## DESCRIPTIVE REPORT

Type of Survey HYDROGRAPHIC

HYDROGRAPHIC SURVEY H-8326 (FIELD NO. PA-05156)

HYDABURG HARBOR S. E. ALASKA

#### Notes to the Verifier H-8326 (unverified) August 1970

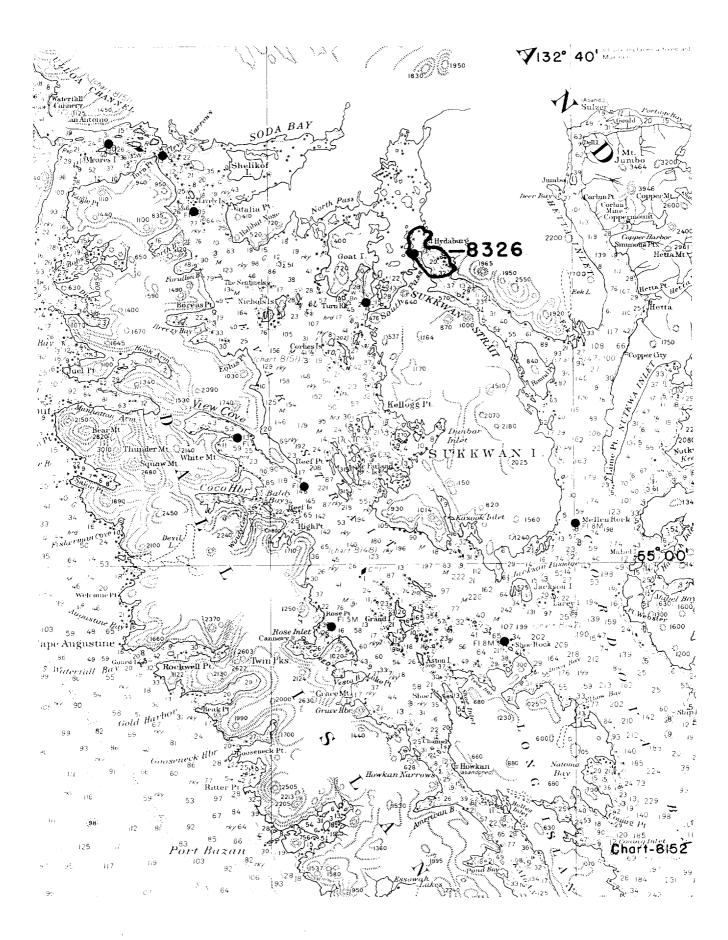
A rock (three feet above MHW) was delineated on photogrammetric survey T-11498. This rock is not shown on hydrographic survey 8326. The rock is located north of triangulation station FIRST, 1925 near hydro signal BAT. It is recommended that this rock be shown on hydrographis survey 8326.
